119607: Land off Abbey Road, Shepley, HD8 8DY

Camstead Ltd
Abbey Road North, Shepley, Huddersfield, HD8 8DY
Planning Application Reference 2019/91638

Client: CAMSTEAD.	Project No: 1305/11	Sheet 1 of 9
Project: ABBEY ROAD NORTH, SHIPLEY	Calc By: ARP	Date: 11/2/20
Element: FLOOD COMPENSATION	Chkd By:	Date:

Client: Scotfield Ltd
Job No: 18.019
Project: Abbey Road, Shepley
Title: Proposed Site Plan
Date: 06/03/18
Scale: As indicated@A1
Checked by: WD
Drawing No: 00-103
Drawn By: MH
Revision: B

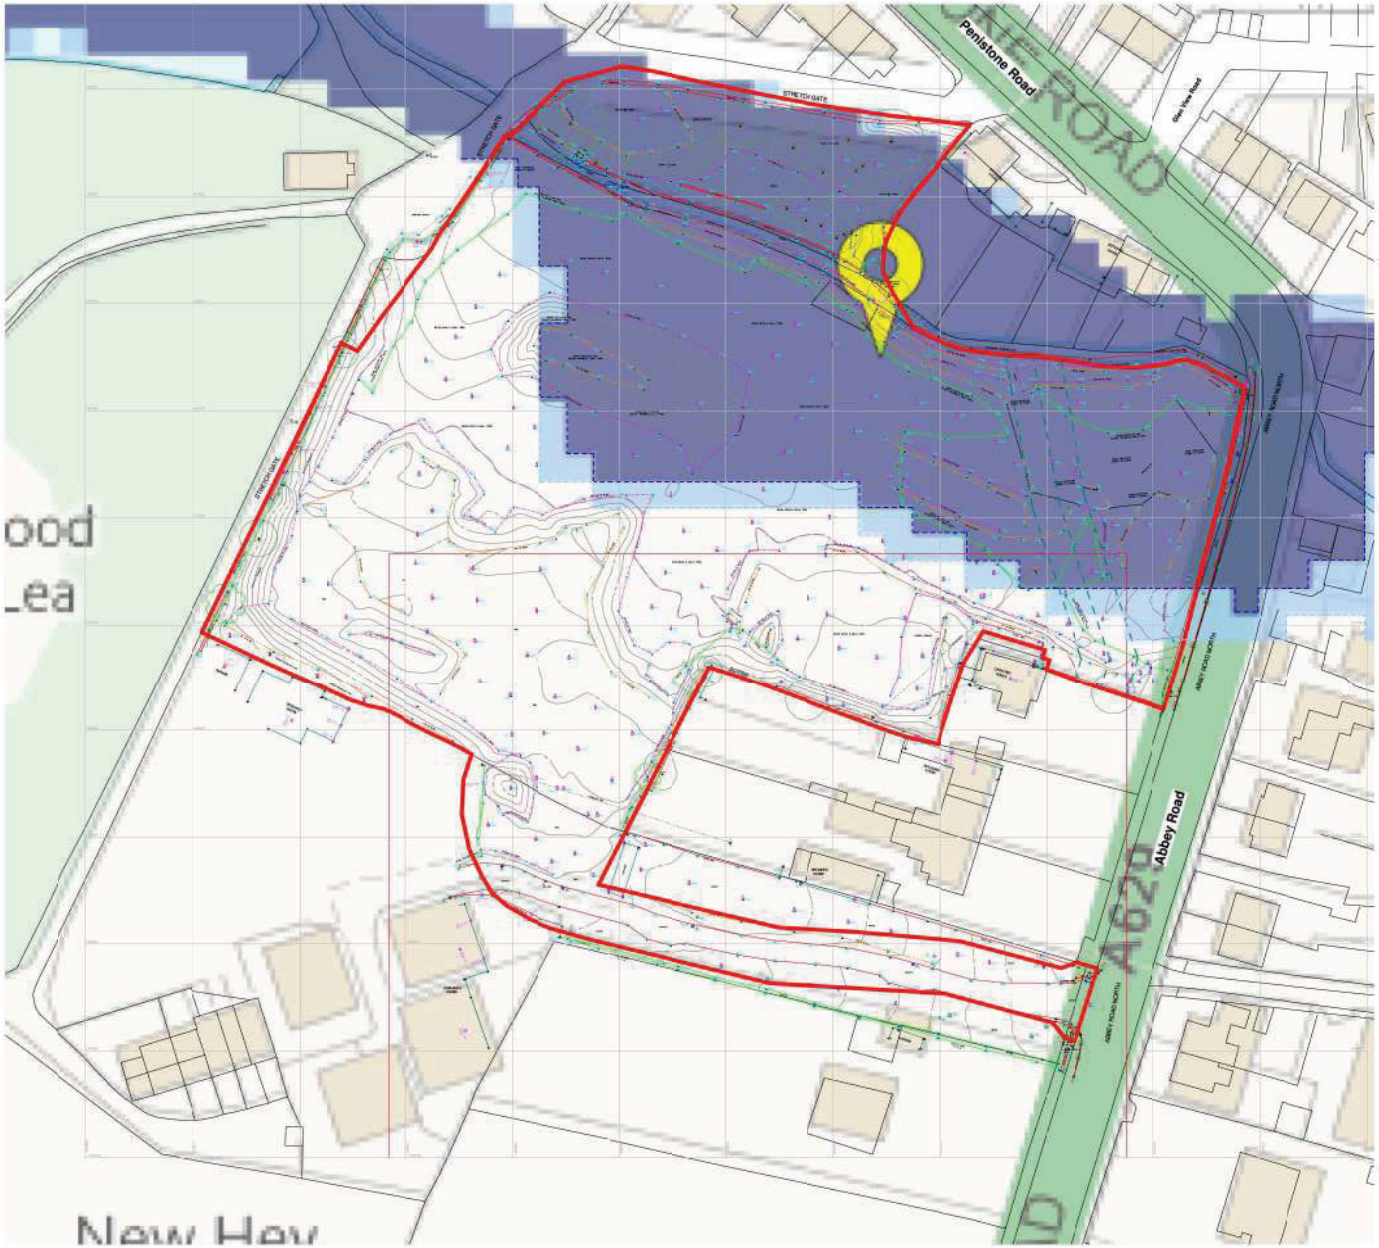
Although the properties and access road appears on the edge of the EA flood zone 3 map plotted in drawing reference 00-103, there is low confidence in the quality of the flood zone outlines in this area as they are based on a National Generalised model.

We note an area above the culvert is to be lowered to provide compensatory storage on the drawing 00-103, the purpose and calculation for this is unclear.

Access and egress roads to the development are close to the area shown on map 00-103 being lowered for compensatory storage this along with opening up the culvert might have impacts in terms of the Emergency access/egress to the site. As this is an Emergency Planning issue we recommend this is discussed with the Flood Risk, Drainage and Emergency Planning Teams at Kirklees Council.

4. In view of the above, we located all the properties within Flood Zone 1 in relation to the Flood Map and prepared a detailed level proposal for the final layout. A copy of the latest drawing from Enjoy Design is attached and you will see that the lowest floor level is 148.4m on the northwestern corner of the site where the flood level in relation to the topographical survey is much lower than the 148.0m contour. In view of this interpretation of the Flood Zone Map and the previous approval of the Fairhurst's Report, we would hope that you are able to accept that the 1% probability level has been assessed correctly and that there is more than 600mm freeboard to allow for climate change up to the finished floor levels of the properties.

5. The proposed layout submitted to the Planning Authority showed that all the properties and adjacent roads and private drives, apart from a small area adjacent to plot 26 were located in Flood Zone 1. However, in consultation with the Planning Authority, there has been a need to introduce a turning head on the private drive opposite plot 18 and this encroaches into the Flood Zone 2 and 3 boundaries. Consequently, we need to provide compensatory storage for these areas and this will be created to the east of the site beyond plot 21 where the land falls within Flood Zone 1. A detailed calculation of the loss of the Flood Zone 3 volume and proposed compensation will be provided under condition of the planning approval.

The drawing reference 00-105 within the Statement of Flood Risk Assessment shows a purple line indicating the 148 mAOD contour line extends further than this Eastern area of the site but is shown not to be in FZ2 or 3

As indicated above there is low confidence in our flood map outlines in this area and this evidence indicates they may be under estimating the risk. This is why we ask that a more detailed assessment of the flood risk to the site is made regarding what the 1% probability level is and how this compared to the topographic survey and EA flood map. An explanation must be provided of the methodology used to reach the estimated 1% level and what the FFL will be based on this plus an allowance for climate change plus 600mm.

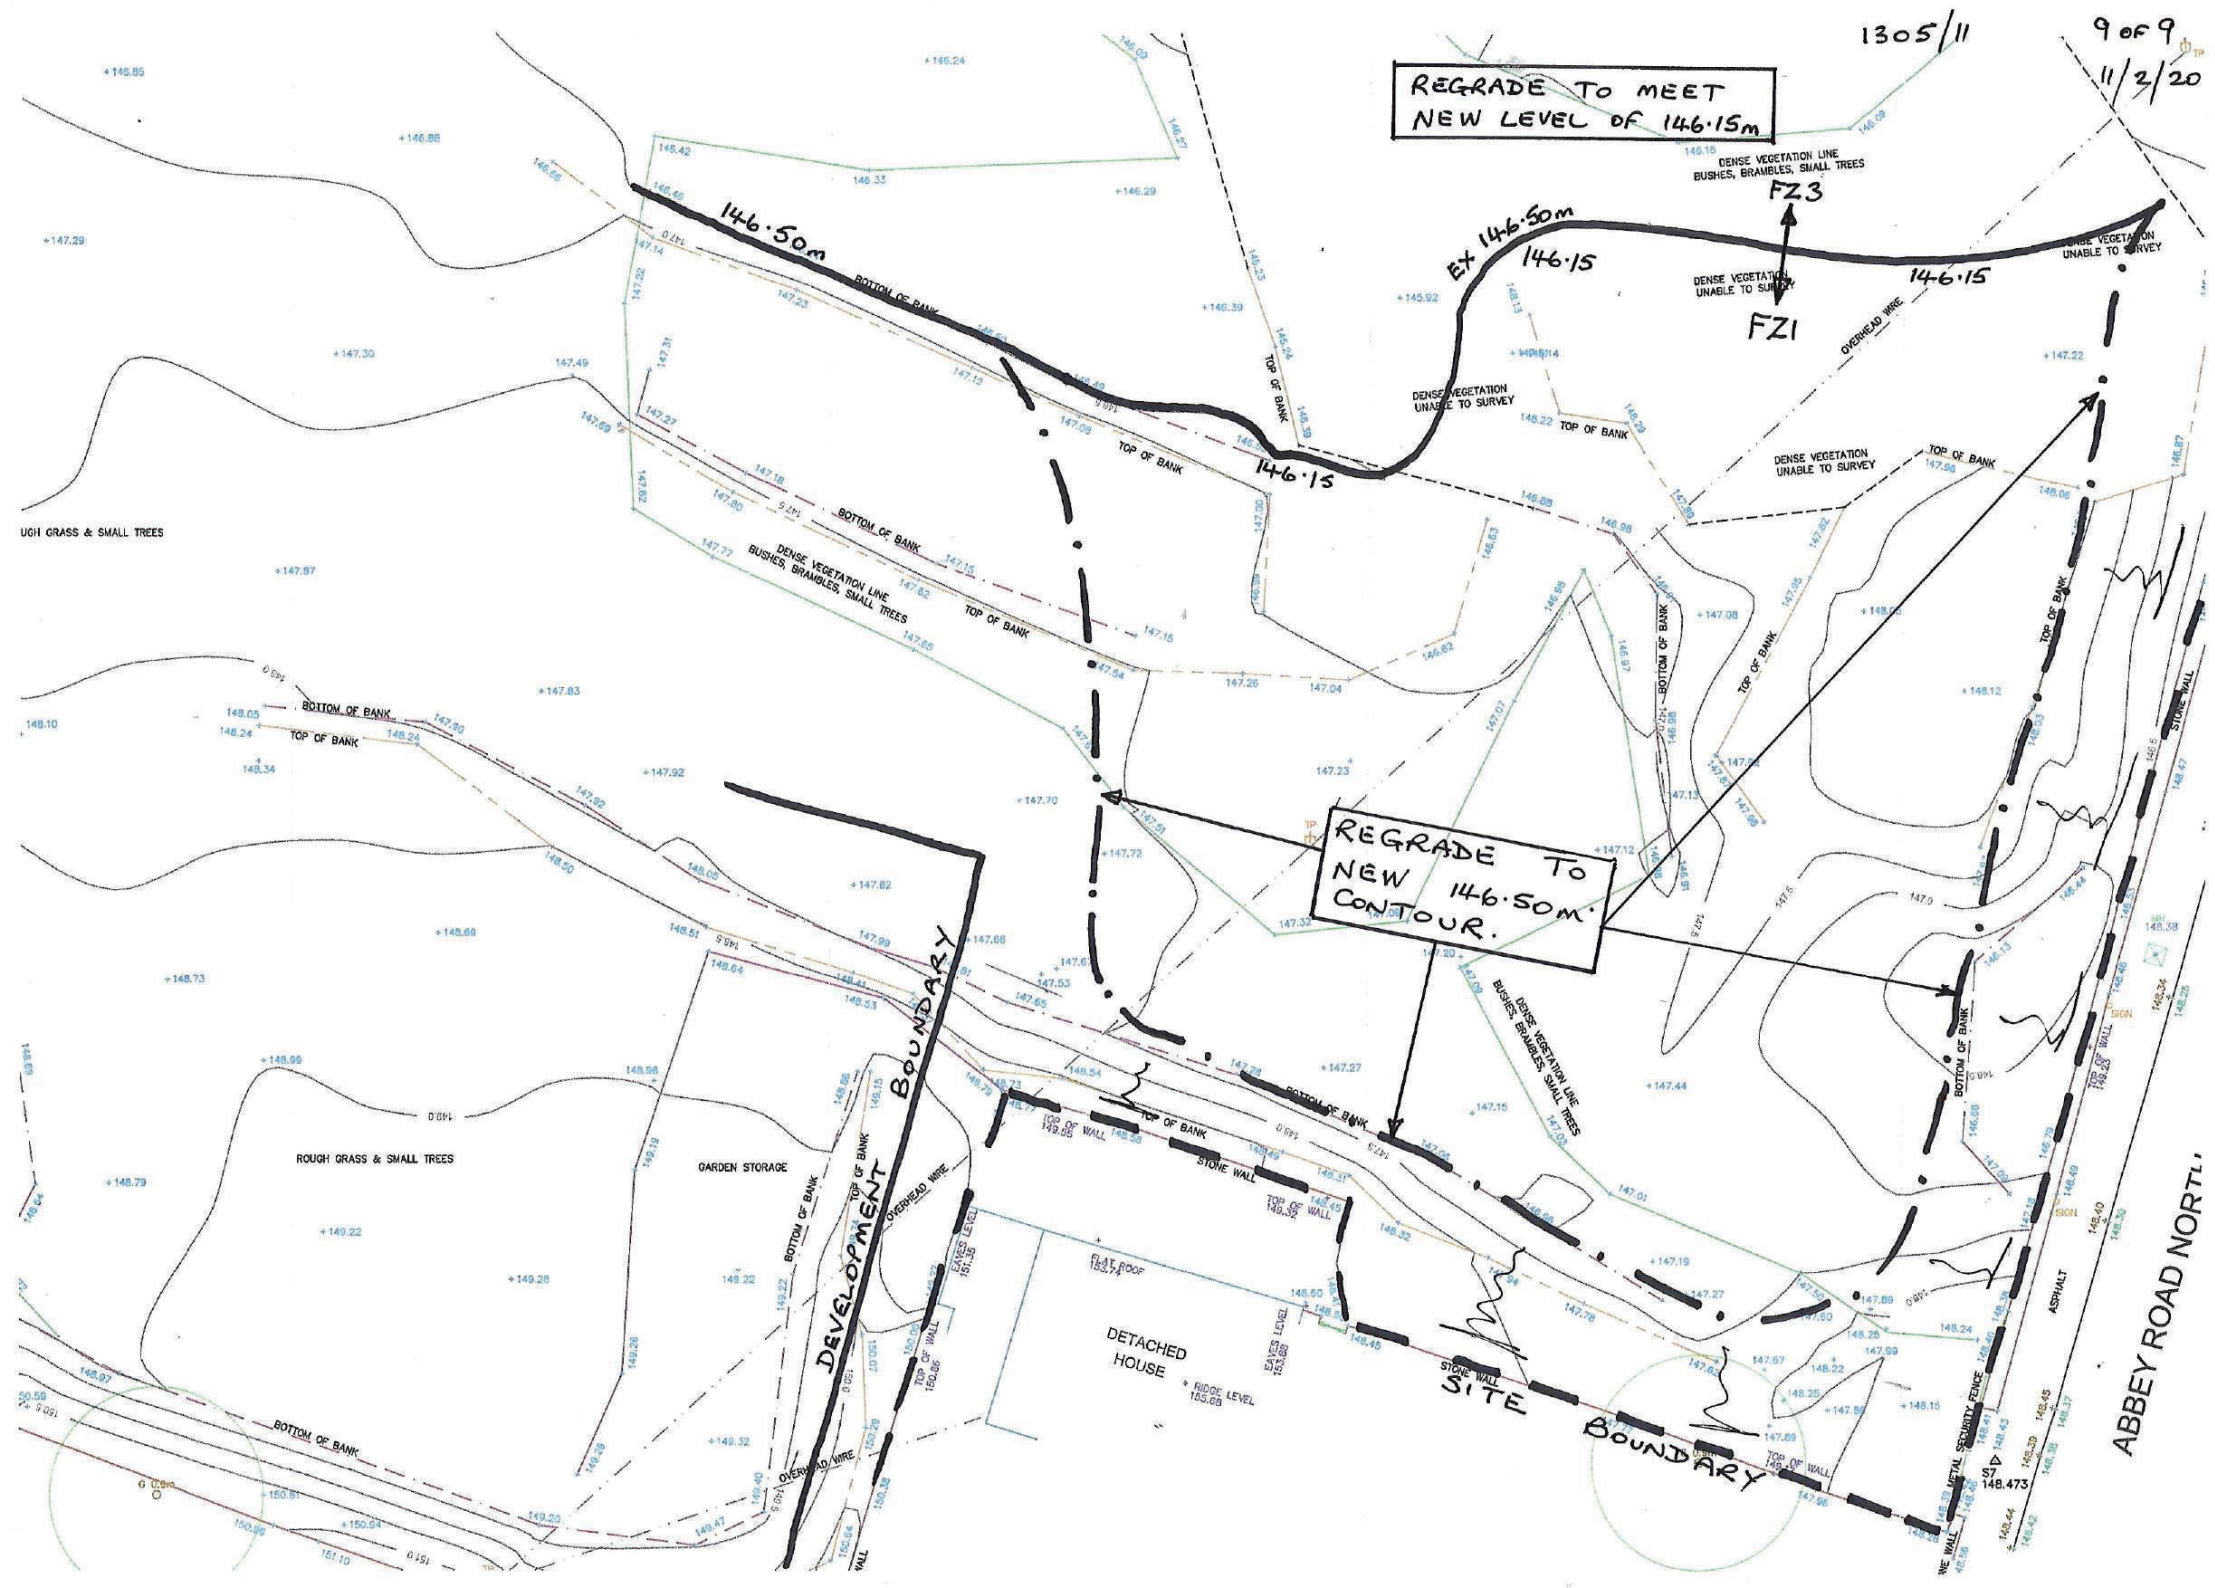
Assuming an embankment slope of at least 1 in 3 from the site/development boundary, the flood compensation area is presented on the plan on page 9.

Area = (26.0 × 12.0)
+ (46.0 × 29.0)
= 1646 m²

∴ Average depth = $\frac{106.4}{1646}$ = 0.065 m.

Available volume is between 106.4m³ - 123.5m³

REGRADE TO MEET NEW LEVEL OF 146·15m
146·50m
BOTTOM OF BANK
TOP OF BANK
DENSE VEGETATION LINE BUSHES, BRAMBLES, SMALL TREES
DENSE VEGETATION UNABLE TO SURVEY
FZ3
FZ1
EX 146·50m
146·15
OVERHEAD WIRE
REGRADE TO NEW 146·50m CONTOUR.
ROUGH GRASS & SMALL TREES
GARDEN STORAGE
DEVELOPMENT BOUNDARY
DETACHED HOUSE
FLAT ROOF
EAVES LEVEL
RIDGE LEVEL
STONE WALL
TOP OF WALL
SITE BOUNDARY
ASPHALT
METAL SECURITY FENCE
SIGN
ABBEY ROAD NORTH
